Subject: Response to NRC, Request for Additional Information (RAI), dated 6/27/07

Docket Number: 50-184

NIST Response to Second Round of NRC
Request for Additional Information
Dated 6/27/07

Figure 2.3.1-3a ASCE 7-93 50-Year Wind Zones

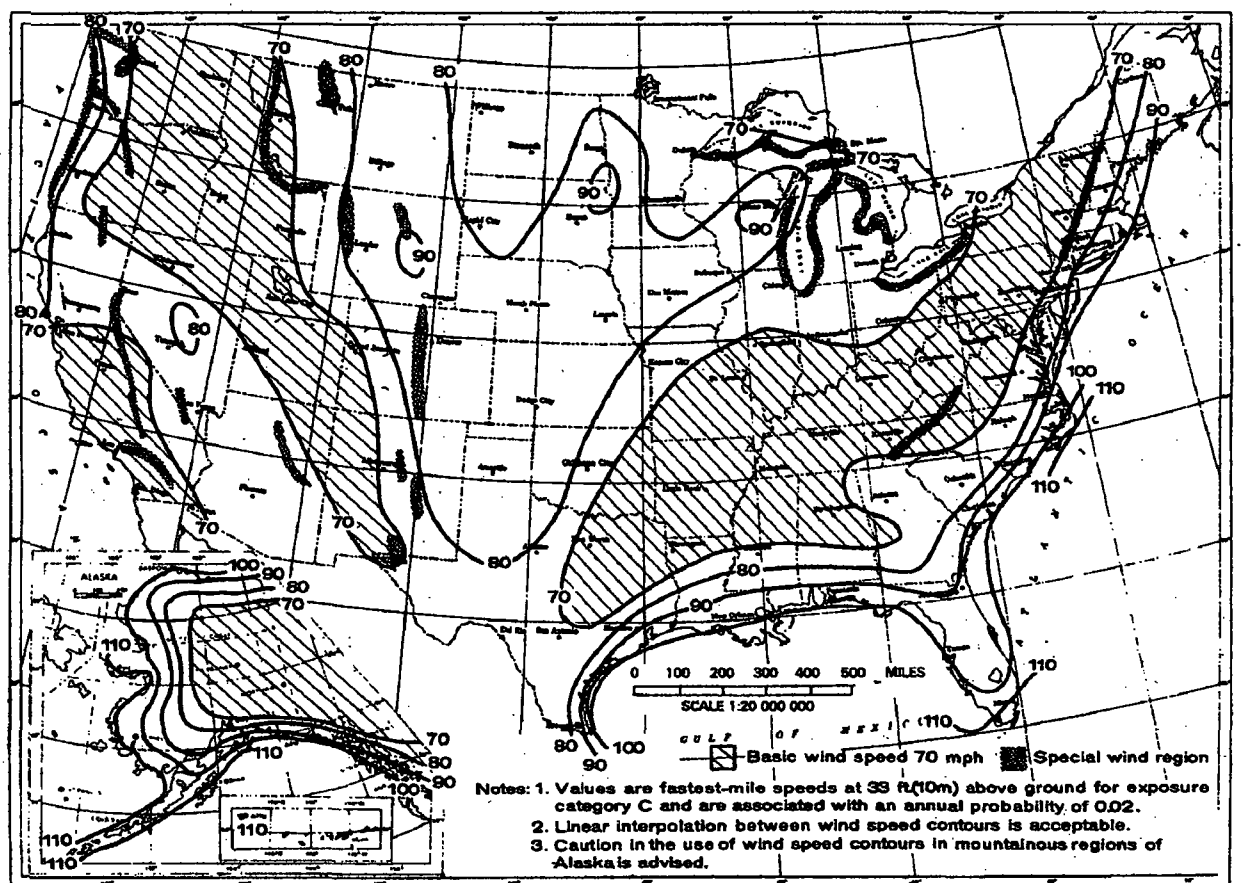
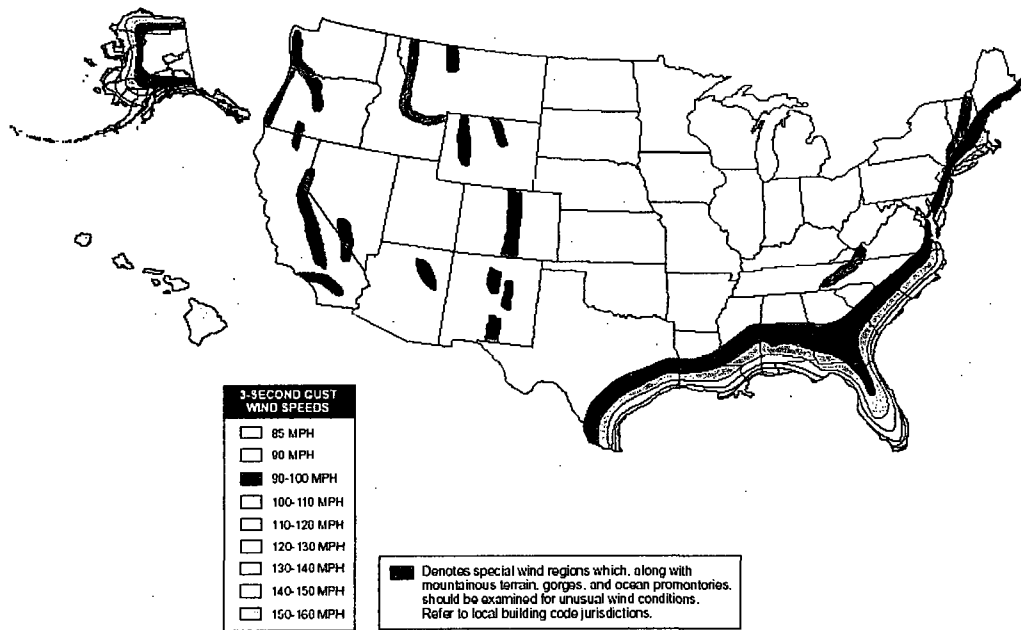
2.2 Provide a reference to the mentioned previous response or a copy of the response.

Historically, multi year return period wind speeds are calculated on a 50-year return period. The most recent standard ASCE 7-98, states that the maximum 50-year return period 3-second wind speed gust for Montgomery County, Maryland is 90 miles per hour (mph). The old standard [Out of Print] ASCE 7-93, states that the maximum 50-year return period fastest mile wind velocity for Montgomery County is 70 mph. [Out of Print] For consistency with the climate study submitted by NIST with the original NRC application, this new study will use the “fastest mile” method.

For reference, Figure 2.3.1-3a illustrates the ASCE fastest mile and 50-year return wind zones for Central Maryland as 70 mph. Figure 2.3.1-3b illustrates the ASCE 7-98 3-second peak gust and 50-year return wind zones Central Maryland as 90 mph.

Figure 4.2.3: Fuel Element Assembly (see Figure 4.2.4 for Fuel Plate Detail)

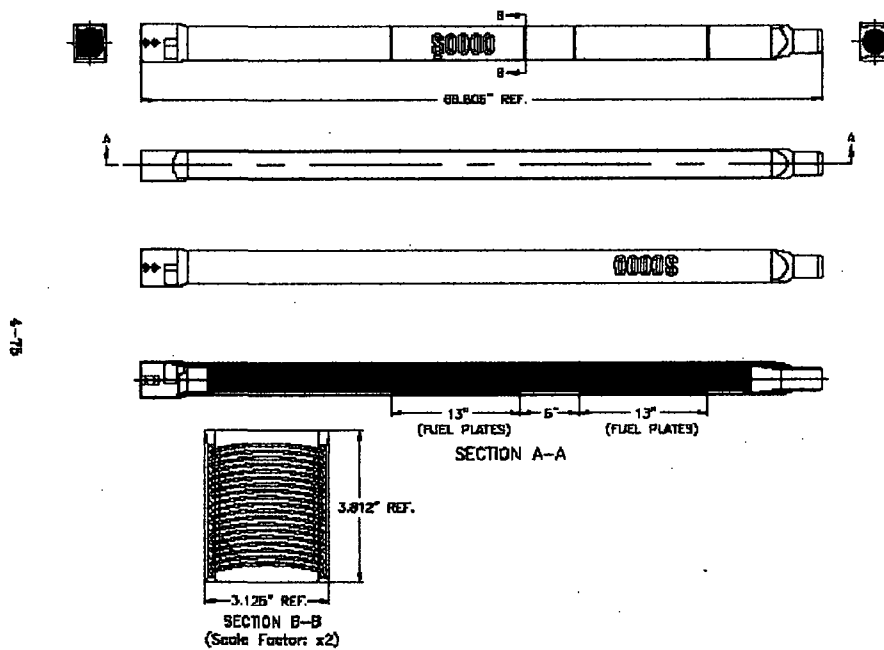
4.2 Provide revised Figures 4.2.3 and 4.2.4, which were not attached to the response.

NIST Response to 4.2
